REF: CS/FCI18006714/ Kvd3⁷²

SHB 9705K

INITIAL INSPECTION REPORT OF VEHICLE NO. SHB 9705K

ADJUSTMENT ON REPAIR COST FOR VEHICLE NO. SHB 9705K

Description of Damage:

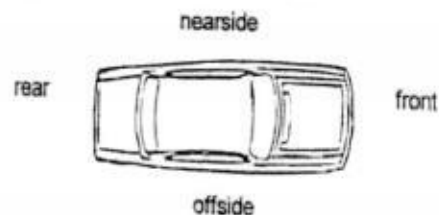
The vehicle sustained damages at the rear portion.

Damages Consistent
